After reviewing the submission, as an owner/occupier in neighbouring building, 12-16 Challis Avenue, I have the following 5 points of feedback:

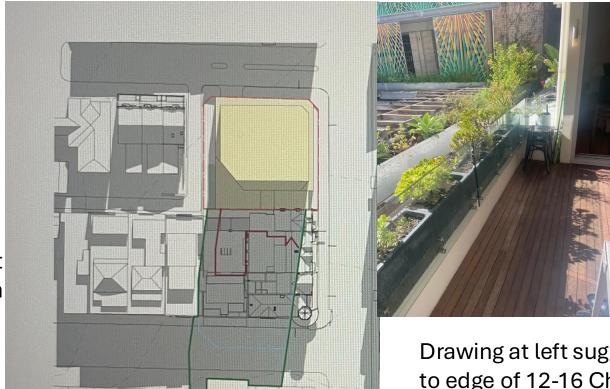
The submission does not make note of what season for sun angle the shadows are sketched.

Red lines drawn for 10am shadow from the existing building show the shadow exceeding the back wall of 12-16 Challis Avenue. The same situation is proven at 9am.

When actual pictures taken at right prove that the shadow lines drawn are inaccurate.

Drawing at left suggests shade at **10am** right to edge of 12-16 Challis. However, actual shadow is far from shading the residence

ENVELOPE - SHADOWS - 11am

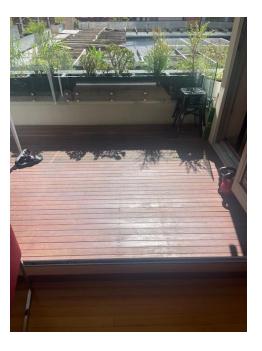
The submission does not make note of what season for sun angle the shadows are sketched.

Red lines drawn for 11am shadow from the existing building show the shadow exceeding the back wall of 12-16 Challis Avenue.

When actual pictures taken at right prove that the shadow lines drawn are inaccurate.

Drawing at left suggests shade at **11am** right to edge of 12-16 Challis. However, actual shadow is far from shading the residence
